PLANNING COMMISSION AGENDA

- A. Roll Call**
- B. Approval of January 13, 2015 Minutes**
- C. Old Business: (None)**
- D. New Business:**
 - 1. SUP2015-001 Request approval of site plan revisions, building elevations, and associated variances pursuant to condition 2G of Gwinnett County case CIC-08-021 for a 6.47 acre retail center development located at 5242 Peachtree Parkway (Corner of Peachtree Parkway and Peachtree Corners Circle); 6th District ; Land Lot 301; Parcel 31**
- E. City Business Items:**
 - 1. Winters Chapel Road Area Study preliminary report presented by Pond + Co.**
- F. Comments by Staff and Planning Commissioners.**
- G. Adjournment.**

**ROBERTS PROPERTIES PEACHTREE RETAIL, LLC'S
 REQUEST FOR SITE PLAN APPROVAL AND RELATED VARIANCES**

PEACHTREE RETAIL MASTER PLAN

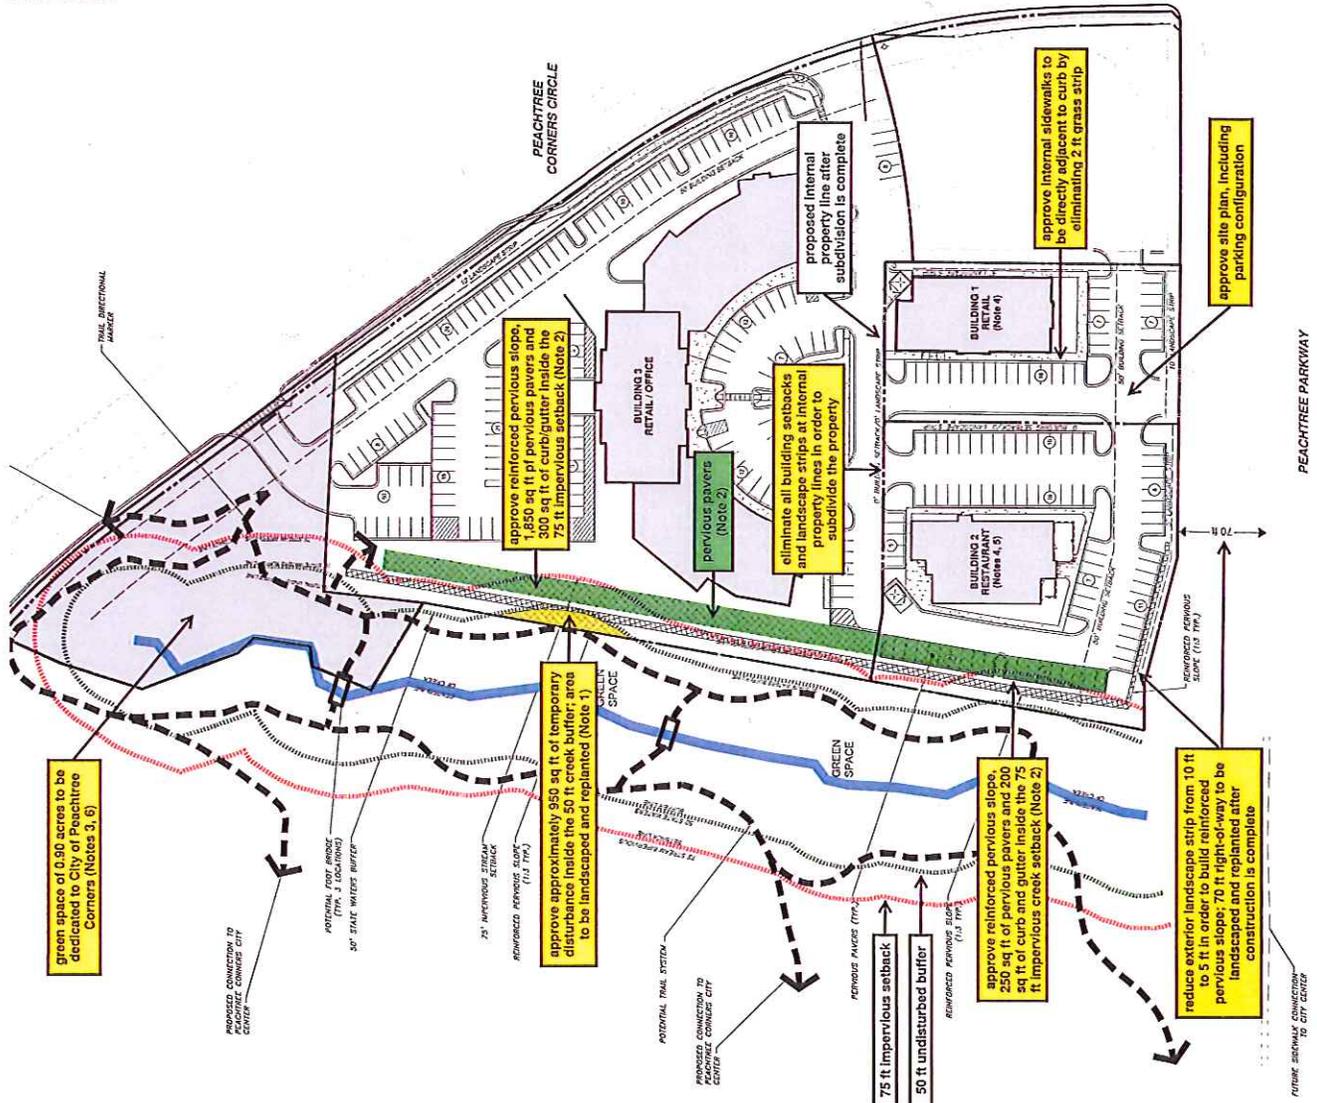
Staff Comment: The applicant would like to extend the reinforced pervious slope into a portion of the front yard which would reduce the required landscape strip in that location from 10 ft. to 5 ft. The landscape strip in front of both the Chase Bank and the Sprouts retail center is 10ft. in width. So, if this variance is granted, the applicant should ensure that the same trees and plant material installed at those other two locations can be accommodated at this site in order to maintain a uniform street front appearance.

Staff Comment: The applicant would like to install a reinforced pervious slope (picture attached) instead of a retaining wall along the northern property line. This type of engineered wall will have a more natural appearance near the stream and is preferable to a standard retaining wall. However, in order to make the site plan work, the applicant needs to encroach into the existing stream buffer. To compensate for this intrusion, the applicant is willing to dedicate .9 acres of land (approx. 4 times the area of intrusion) to be added to the Town Center trail system and preserved as green space. This .9 acres is in a significantly strategic location between the applicant's property and Peachtree Corners Circle. It will benefit the Town Center project to have this additional land for the planned pedestrian trail.

- 2. Temporary disturbance area shown on the Peachtree Retail Master Plan dated 2/27/15 shall be replanted as approved by the City Arborist.
 - 3. Internal landscape strips and parking areas shall be developed substantially as shown on the Peachtree Retail Master Plan dated 2/27/15.

- 4. Pervious pavers shall be installed as shown on the Peachtree Retail Master Plan dated 2/27/15.
- Y. Building Elevations shall be approved subject to the following:

FRONT ELEVATION 2/27/15

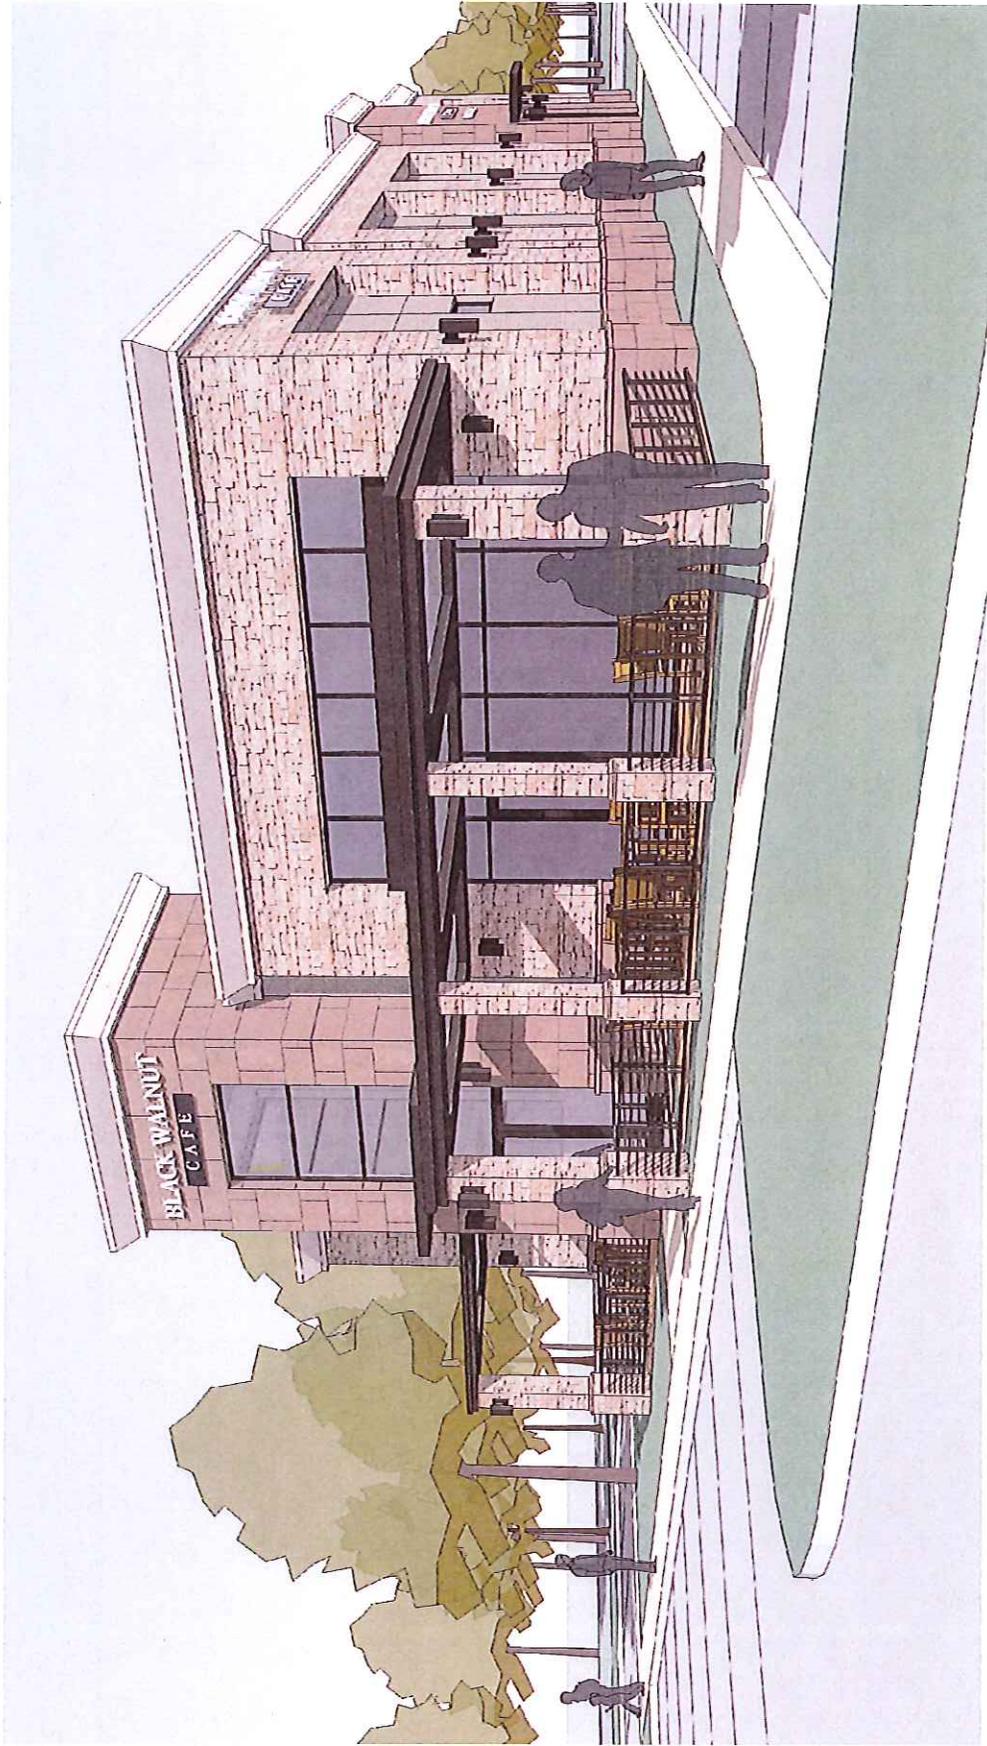
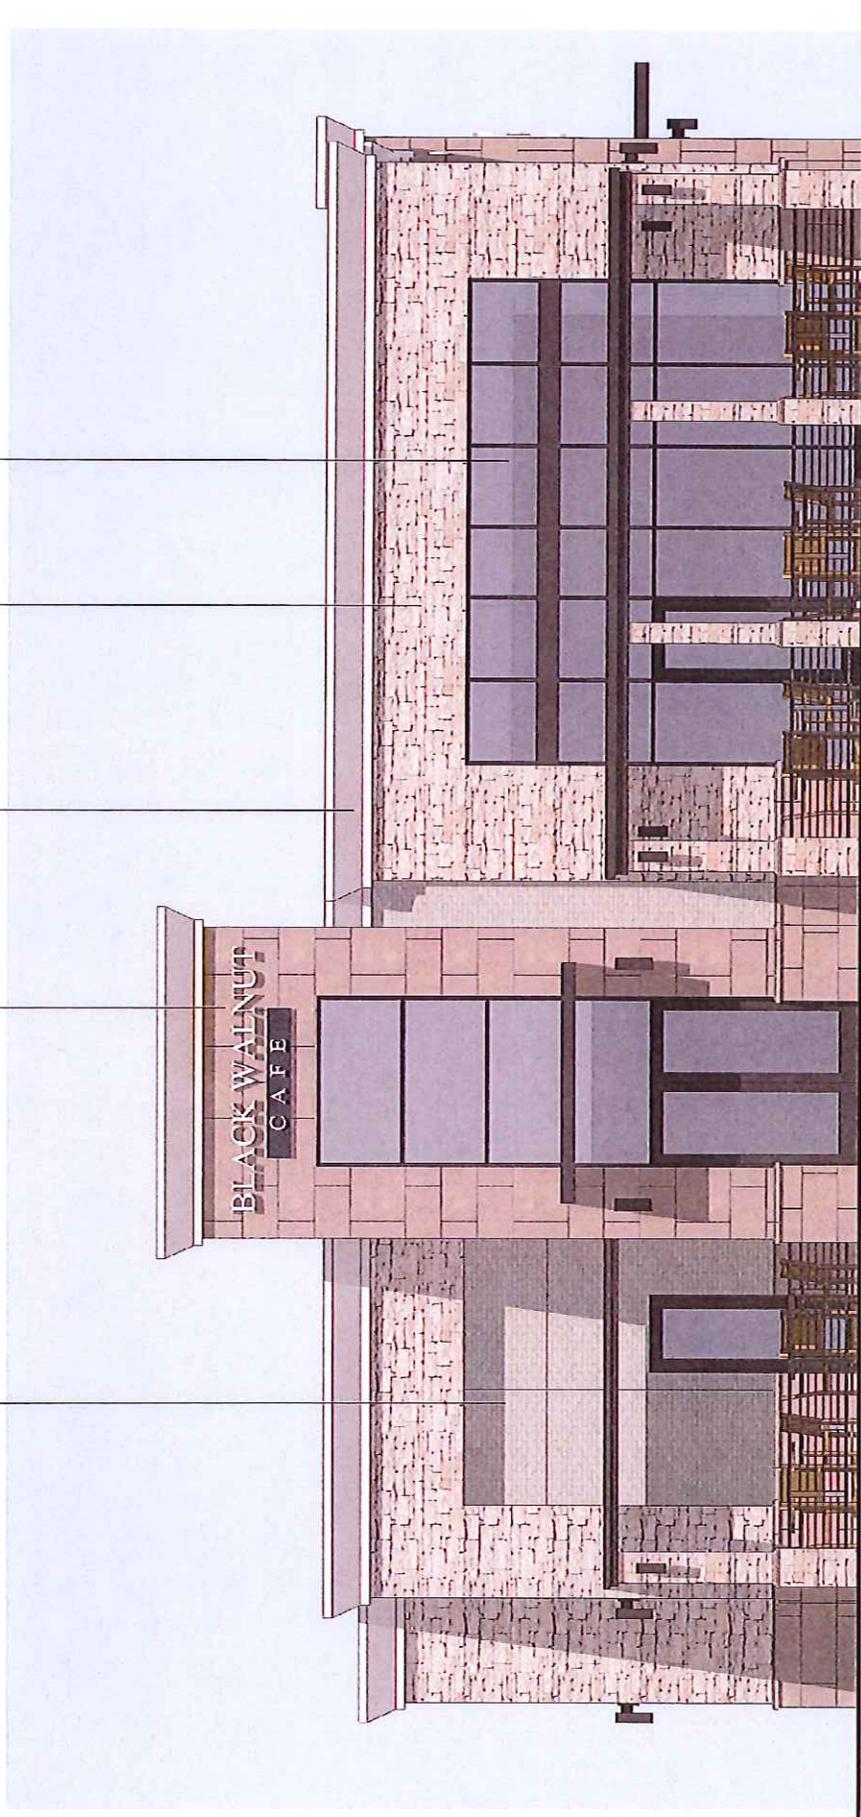
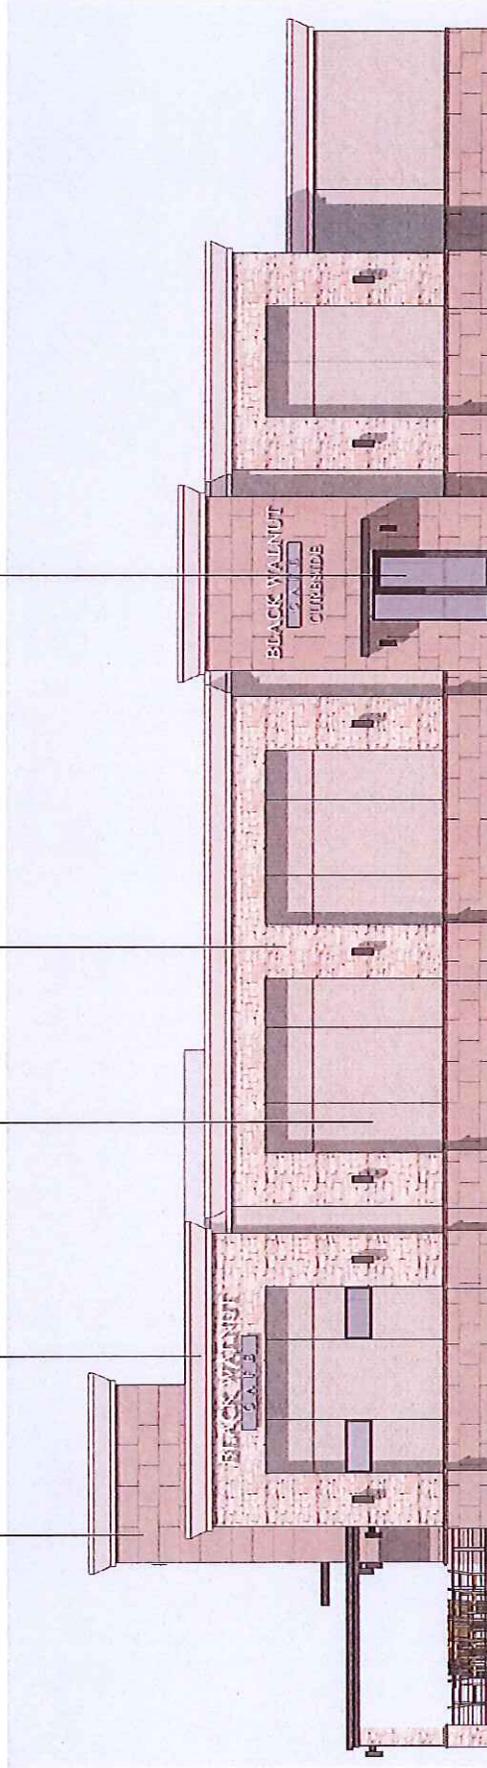
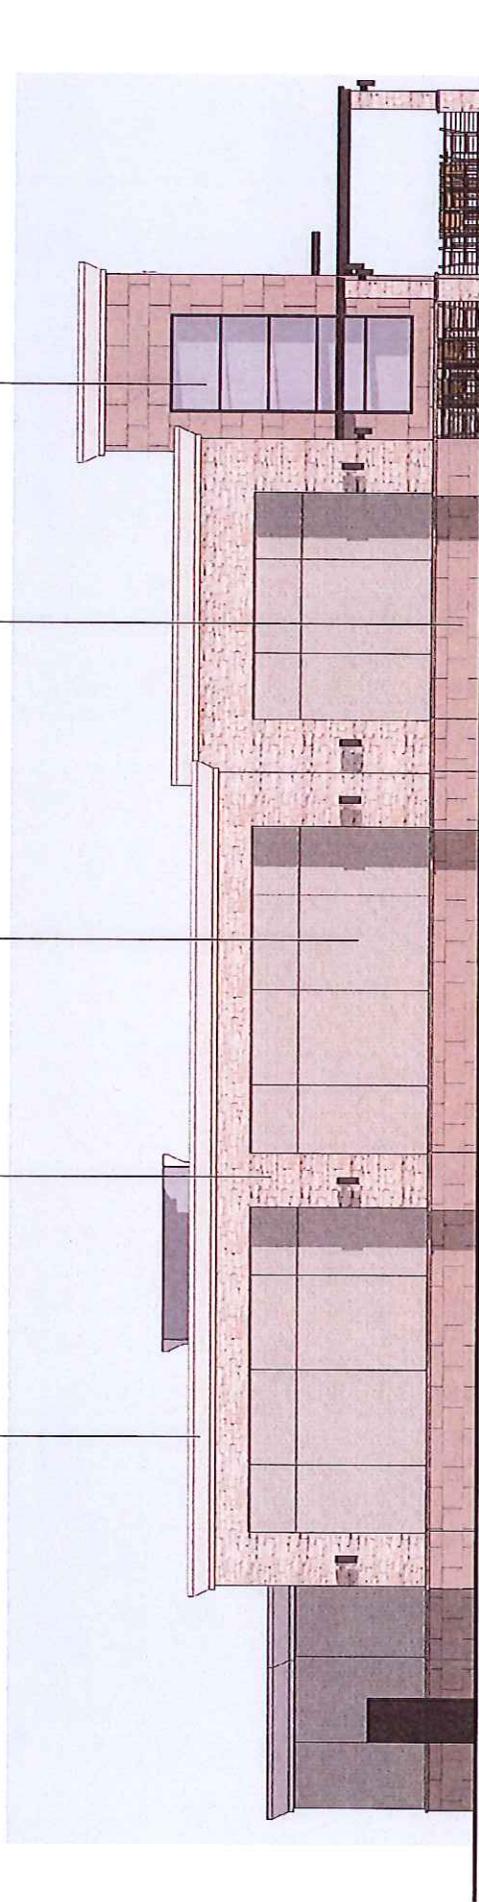
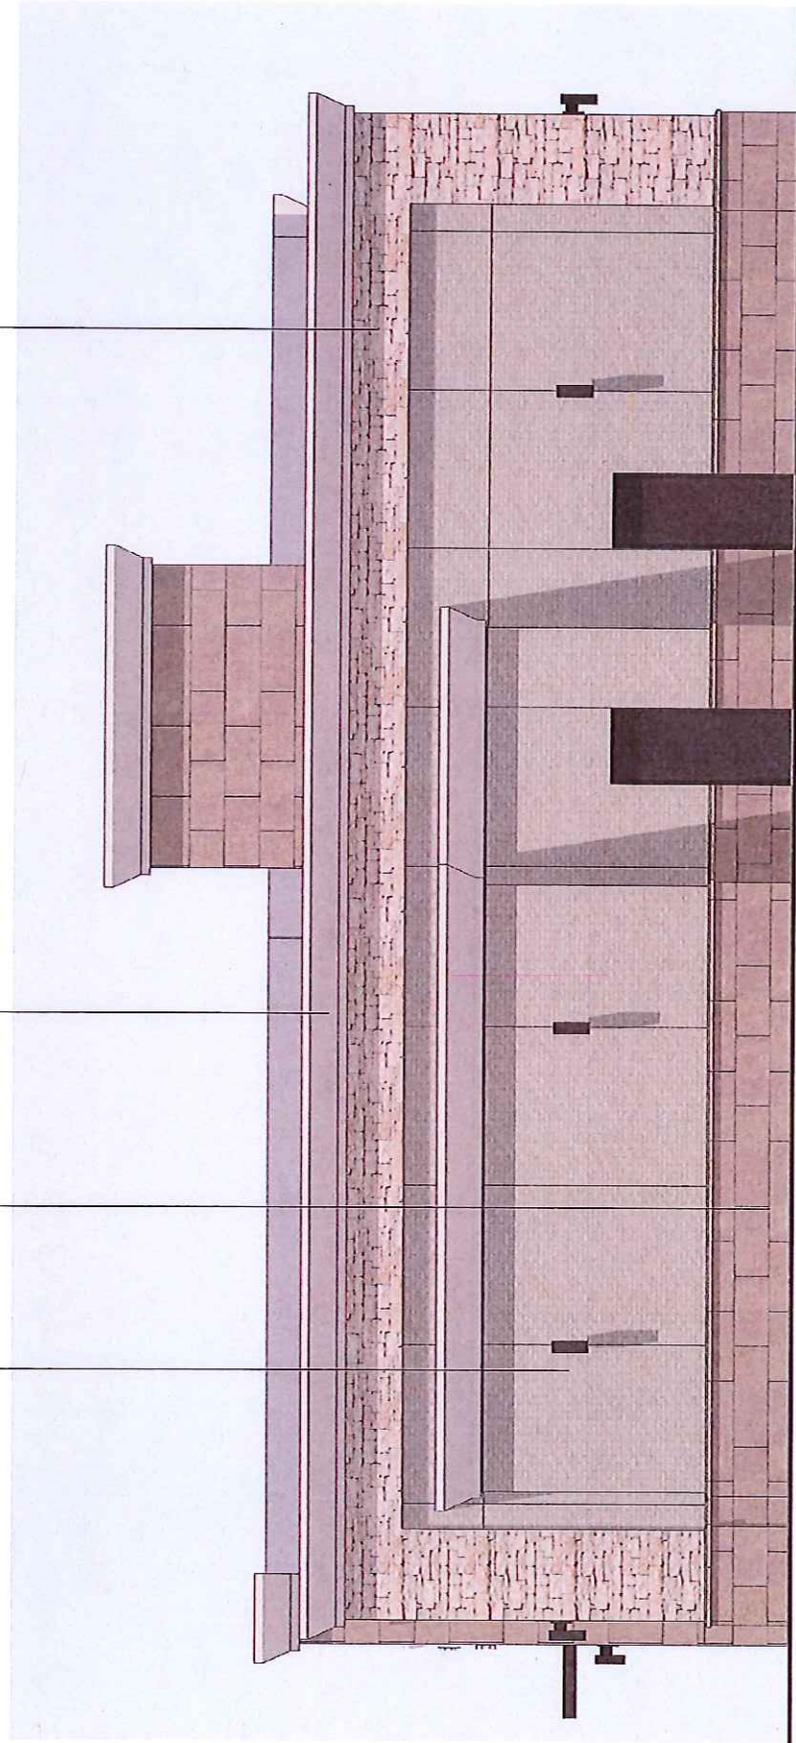
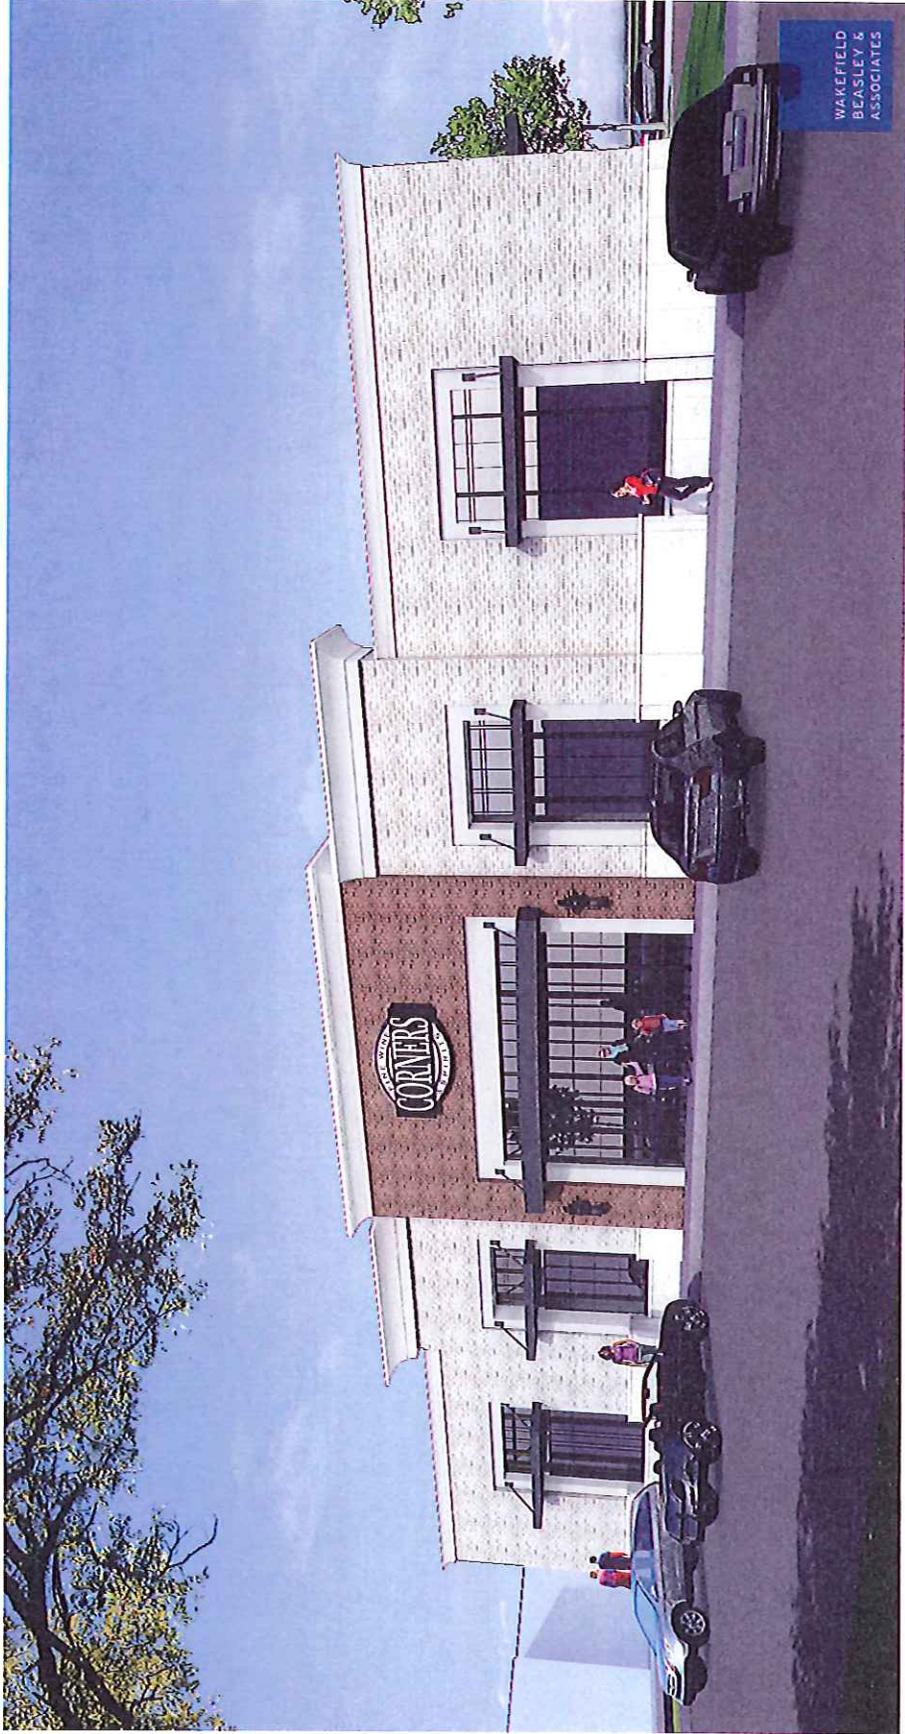
Elevation approval is only being requested for the two buildings along the front. The larger building at the back of the site has not been designed and drawings will need to be submitted in the future for consideration of those elevations. The most current elevations (attached) would be more characteristic of and comparable with the 'Forum/Avenue style' appearance than the original approved elevations. The proposed elevations have a more contemporary aesthetic than either the original plans or the Forum. The exterior of the buildings have a primarily stone and brick appearance with stucco accent bands along cornice lines. The elevations show a flat roofline and the visual diversity in building height is provided by taller elements at the entrance to the buildings.

Except for the proposed roof line, the building elevations, as currently provided, most closely resemble a 'Forum type' development in appearance, layout, and building type. The use of awnings, variations in fenestration, and enclosed outdoor seating areas are similar to elements used at the Forum. Other Forum-like elements such as planters next to buildings and along walkways have not been included, but can be added as a condition of approval. In summary, the submitted plans appear to meet the intent of a 'Forum type' development as required in the original Gwinnett County zoning case.

- 3. Planters with vegetation approved by the City Arborist shall be placed along the building exterior or, as an alternate, climbing plant material shall be installed at the base of the buildings or next to trellises or arbors.
